Nighthawk Gold Corp. Water Licence Applications

W2021L2-0004 & W2021L2-0005

April 12-13, 2022

EQC Application

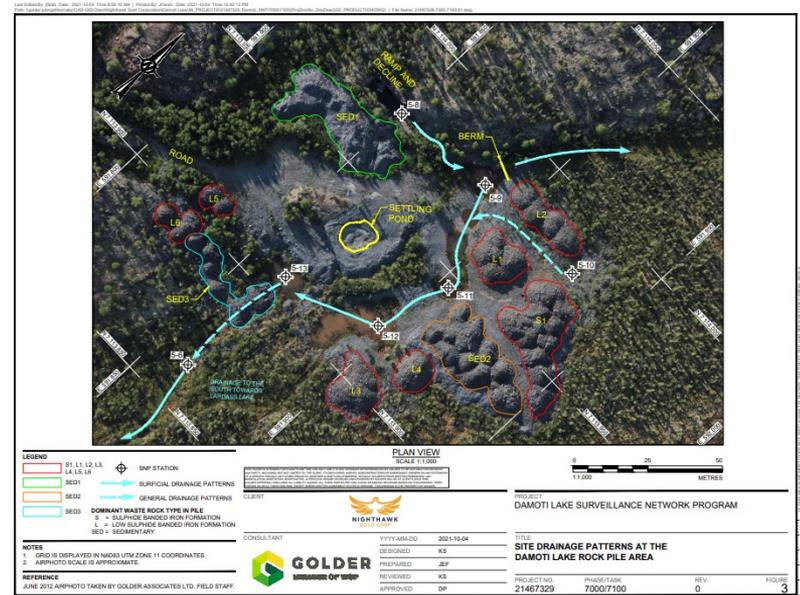
- Nighthawk proposes to change the locations where EQC will be met.
- Currently, EQC must be met at all locations where waste enters the receiving environment.
- Nighthawk proposes the change that EQC must only be met at SNP 5-6 and SNP 5-2.
- Nighthawk believes this is appropriate to protect aquatic ecosystems.
